ENVIRONMENTAL ASSESSMENT OF CONCEPT PLAN CRONULLA SHARKS DEVELOPMENT : 461 CAPTAIN COOK DRIVE, WOOLLOOWARE

RESPONSE TO NSW DEPT OF PLANNING & INFRASTRUCTURE REGARDING LOADING DOCK POSITION & CAR PARKING FOR RETAIL COMPONENT

ANNEXURE A: 40m MINIMUM OFFSET DIAGRAM

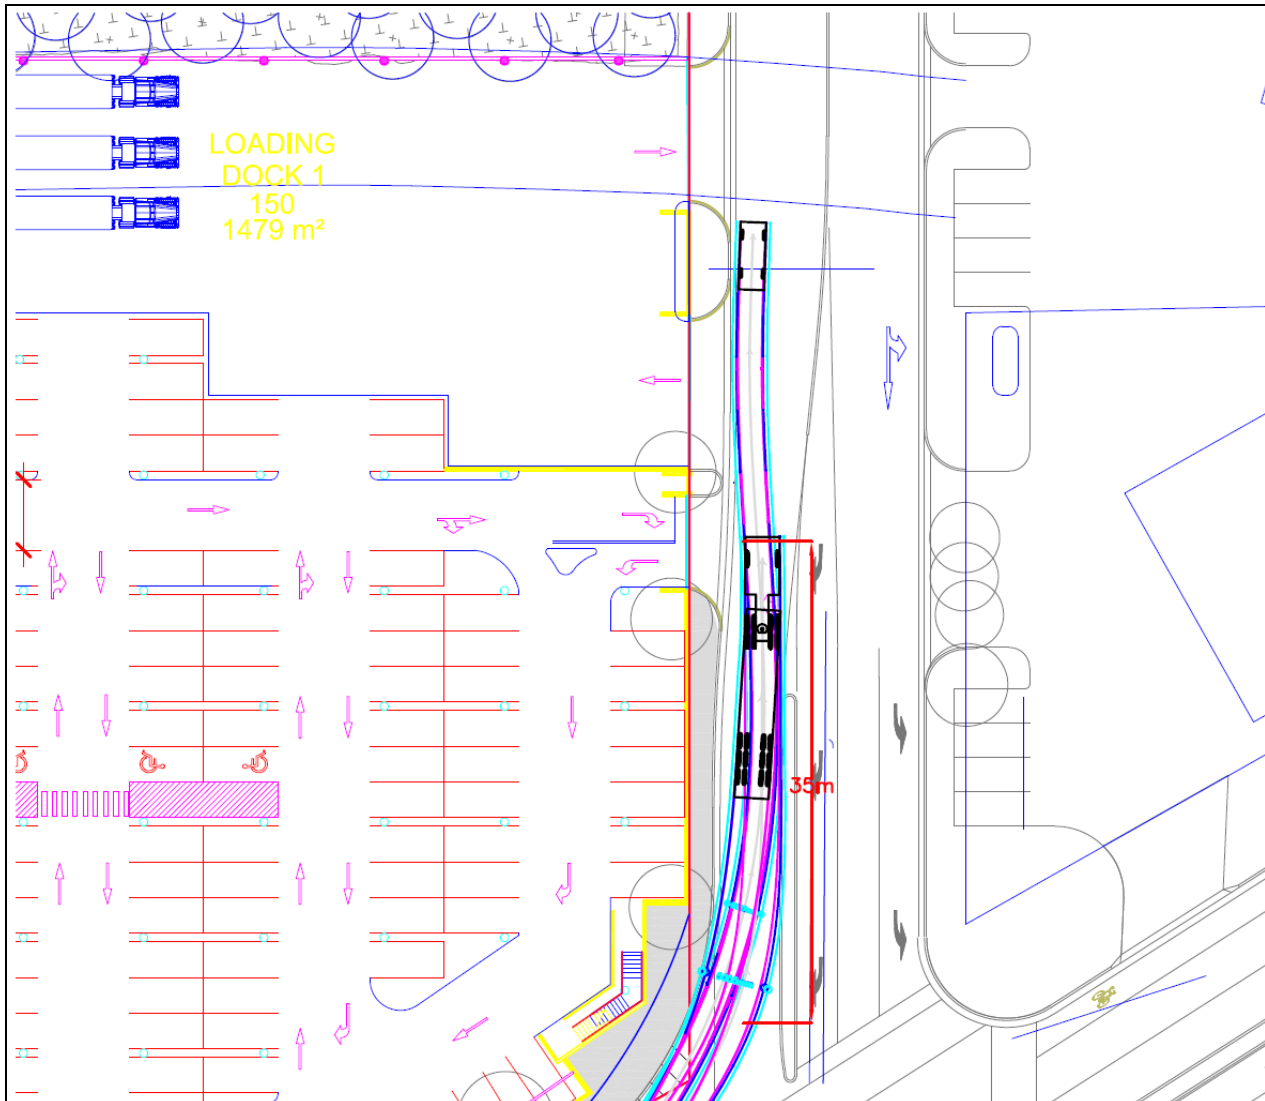
In essence the entry to the loading dock area cannot be any closer than 40m to the future traffic signals at Captain Cook Drive based upon road safety considerations and the proximity of the car park entry and exit driveway.

However, given that the issue of ONE vs TWO retail signals has not been resolved to date, it is best that the location of the dock entry & exit arrangements be at its MAXIMUM ATTAINABLE OFFSET from the future signals. Whilst the car entry/exit lanes are able to be managed by a central median to effect a left-in/left-out condition in the event that one set of retail signals eventuates, the same cannot be said for the loading dock driveways. In

particular the EXIT driveway from the loading dock should be as far north as possible to avoid conflict with typical vehicle queue lengths along this road segment associated with vehicles leaving the shopping centre car park from the future traffic signal controlled intersection with Captain Cook Drive.

However, given that the issue of ONE vs TWO retail signals has not been resolved to date, it is best that the location of the dock entry & exit arrangements be at its MAXIMUM ATTAINABLE OFFSET from the future signals.
